NOTICE OF DECISION

CLASS 3 SITE PLAN REVIEW / CLASS 2 ADJUSTMENT CASE NO.: SPR-ADJ25-09

REQUEST: A Class 3 Site Plan Review site for improvements to Bailey Ridge Park, including restoration to portions of Chambers Swale and construction of a new pathway linking Illahe Court S and Tayside Street S, with a Class 2 Adjustment to eliminate the lighting requirement for pedestrian connections under SRC 800.065(c), for property approximately 5.5 acres in size, zoned PA (Public Amusement), and located at 3801 Tayside Street S (Marion County Assessor's Map and Tax Lot number: 083W06CC / 13900).

MATERIALS &
LAYOUT PLAN -
WEST

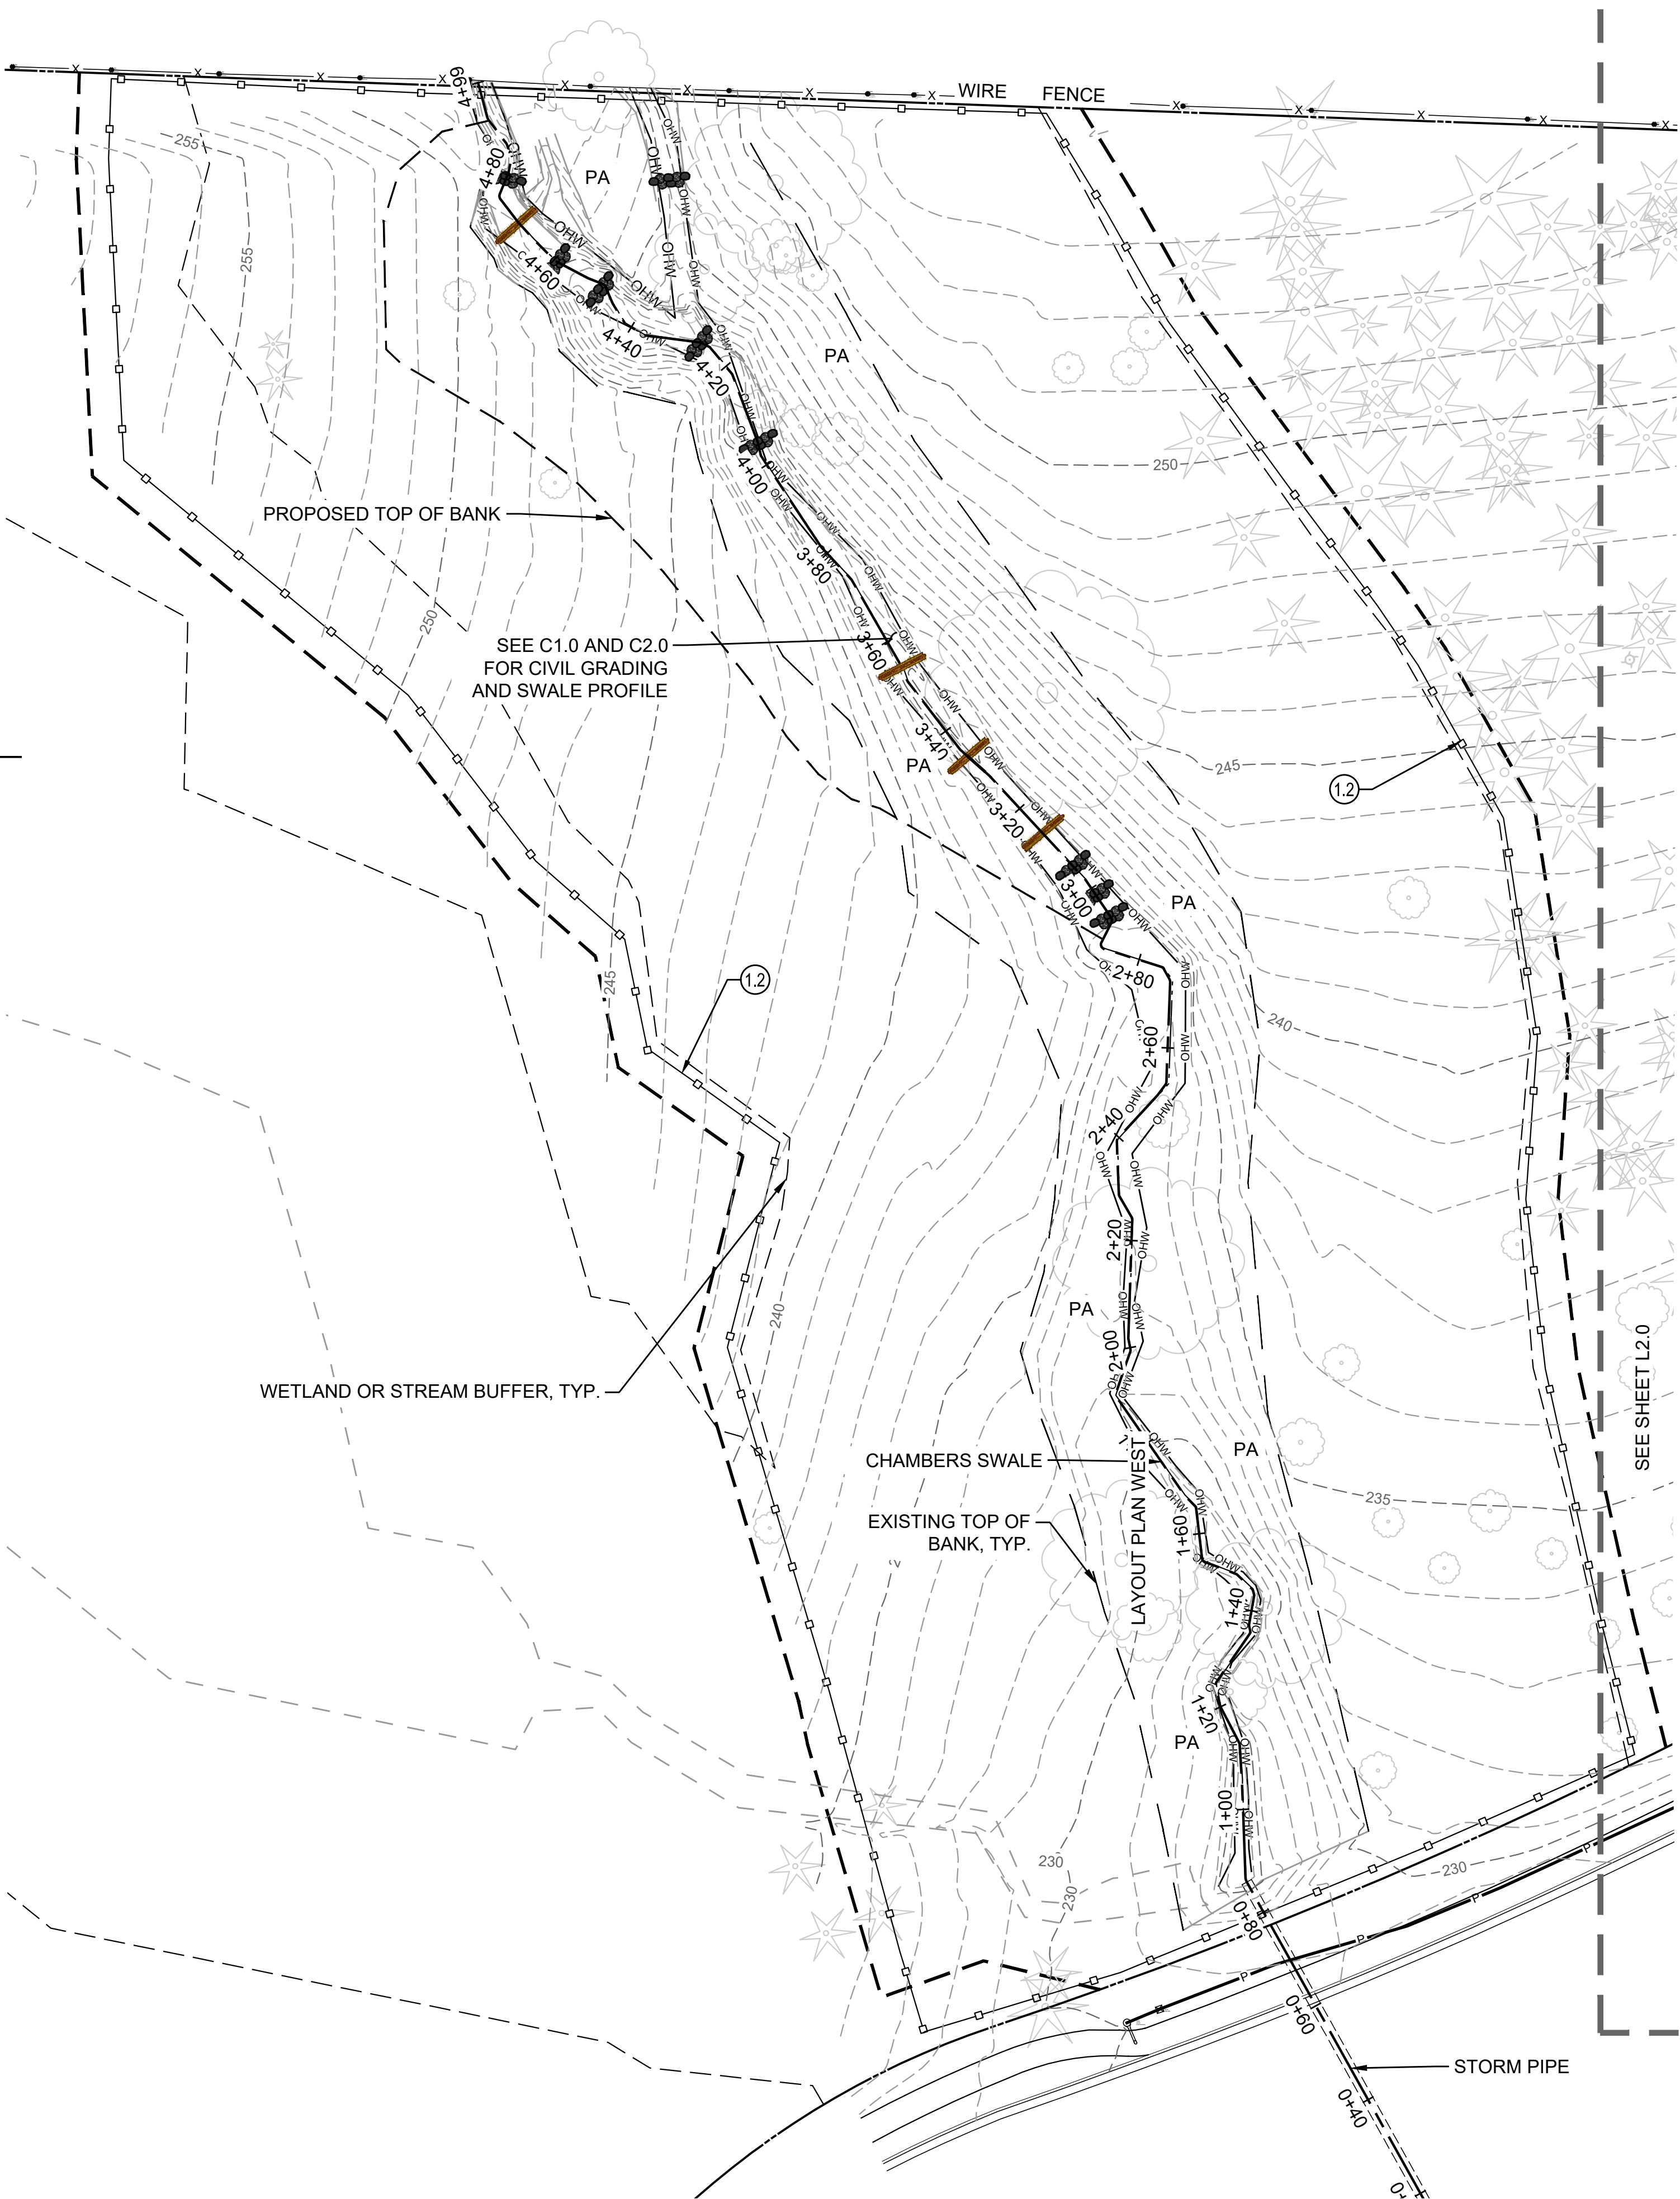
Finding: The applicant's plans indicate only two feet between the bicycle racks located side-by-side, when the minimum spacing requirement should be three feet. Therefore, the following condition applies:

Additionally, two of the bike racks are proposed within the public right-of-way. The applicant can choose to remove these two racks, as more the required minimum is provided, or coordinate with Public Works to verify conformance with any requirements for locating them within the right-of-way. Further conformance with these standards will be evaluated at the time of building permit review.

Condition 1: At the time of building permit review, the applicant shall provide the location and installation details for the new bicycle racks indicating conformance with SRC 806.060.
